1978 - 1980 Corvette: Service Bulletin: Instrument Cluster Area Squeak

Source: Chevrolet Dealer Service Technical Bulletin

Bulletin No: 80-T-37

Date: May, 1980

CORVETTE INSTRUMENT CLUSTER LENS
LOCATING TABS

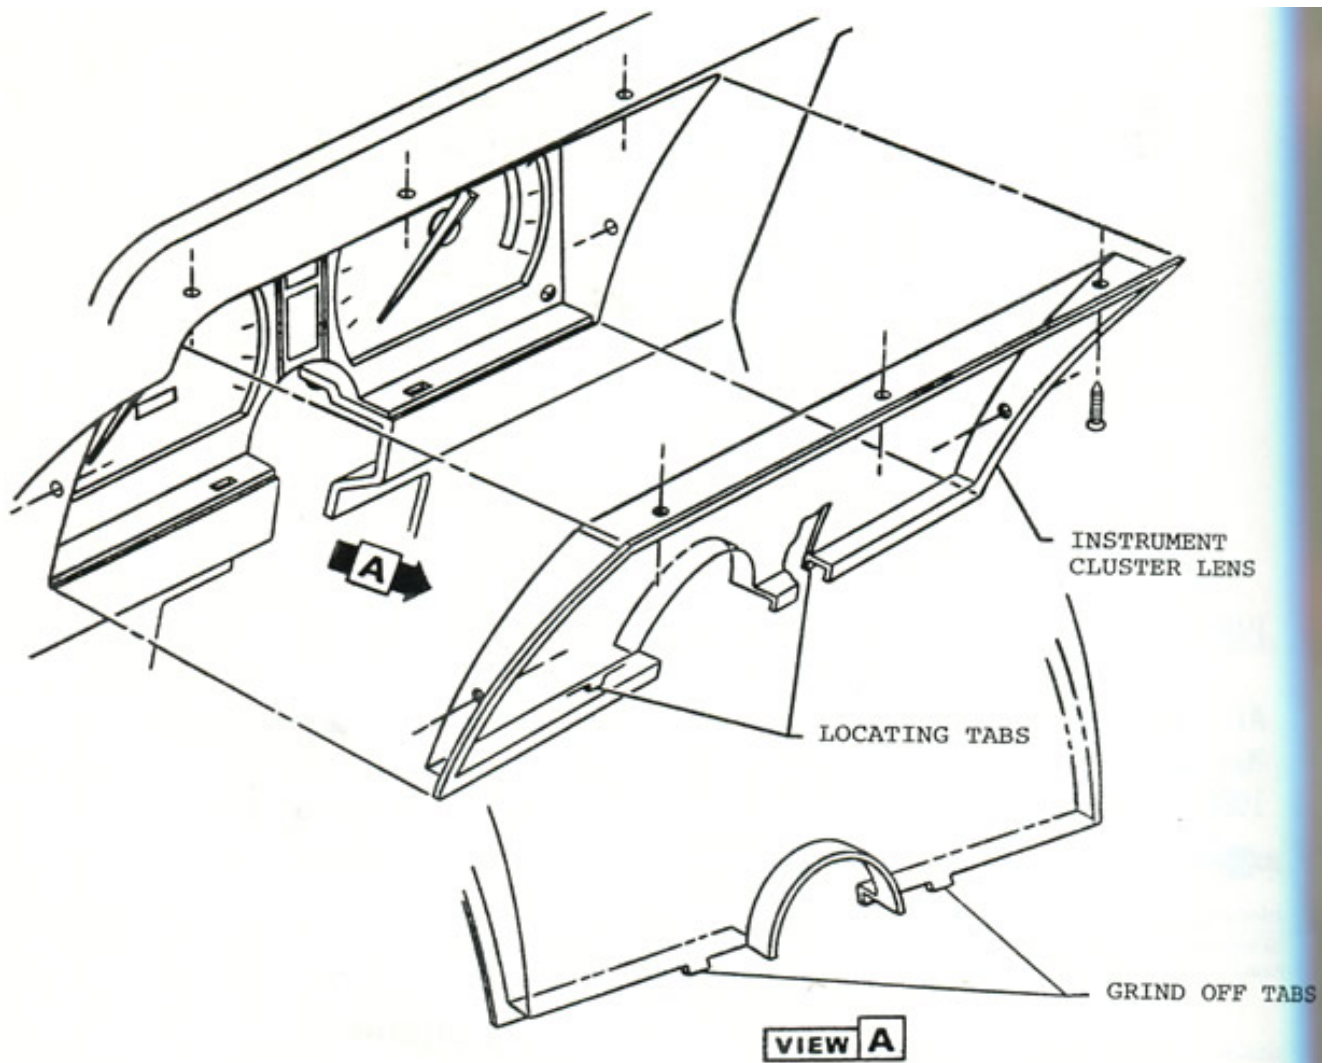
Lower tabs on cluster lens may rub against side of case locating holes. To verify this source, apply light hand pressure to lens.

Tabs will be removed from lens effective May 15, 1980.

1. Remove five (5) lens to case attaching screws and remove lens.
2. Grind off and file to a smooth surface the two (2) plastic locating tabs at bottom of lens, as illustrated on Page 2. CAUTION : The plastic lens is brittle and may crack if the tabs are snapped off rather than ground.
3. Reinstall lens to case with five (5) screws.
